## Product / Process Change Notification (PCN)

**PCN #:** PCN\_IndTIS\_20220607

**Affected Series:** WE-TIS; 7447471xxx

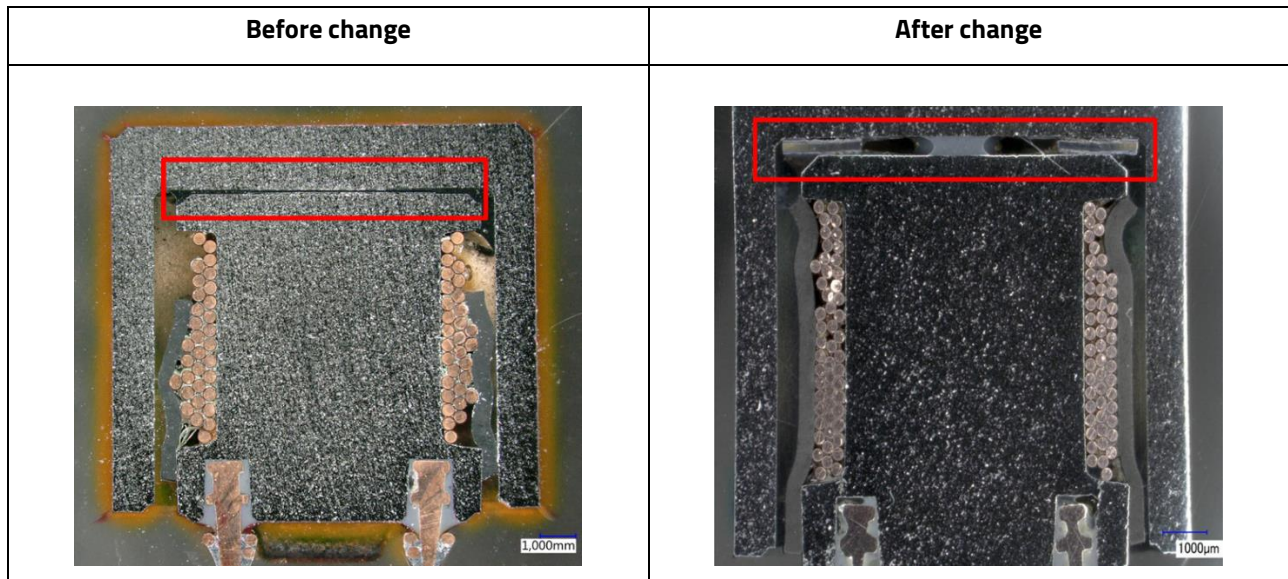
There will be three changes for the size 1111 of the product series WE-TIS.

- To increase the production capability, Würth Elektronik will move the production to a new production site.
- With the aim of an extended product applicability, Würth Elektronik will change the inner construction of the product.
- Due to packaging optimizations, Würth Elektronik will change the tray packaging type.

All products with date code 2022-06-07 or later, will be affected by these changes.

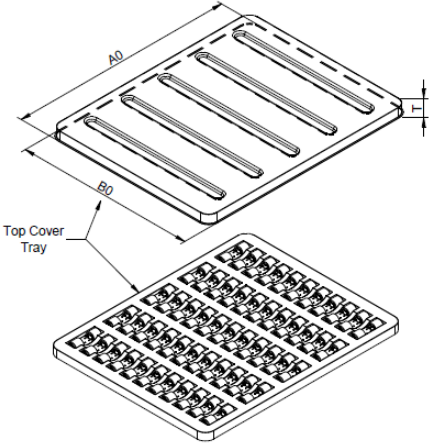
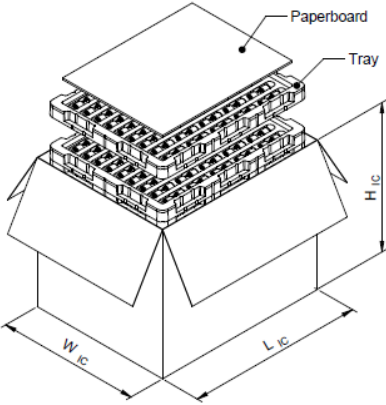
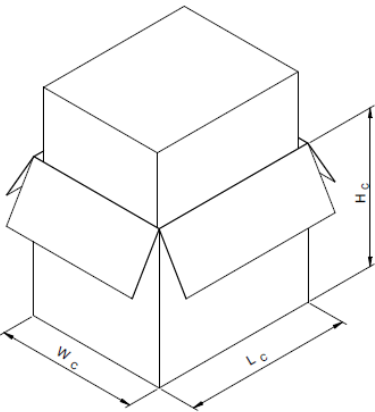
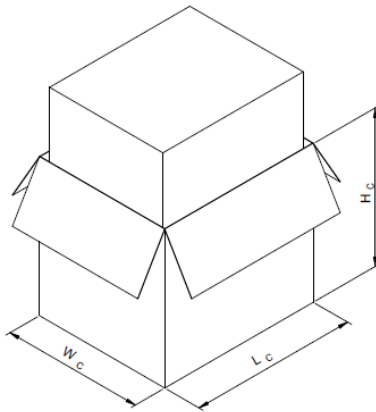
- The new production site can be identified by the first three digits of the lot number

Already established production sites	New production site
Lot number beginning with 227 Country of origin: China	Lot number beginning with 321 Country of origin: China
Lot number beginning with 363 Country of origin: China
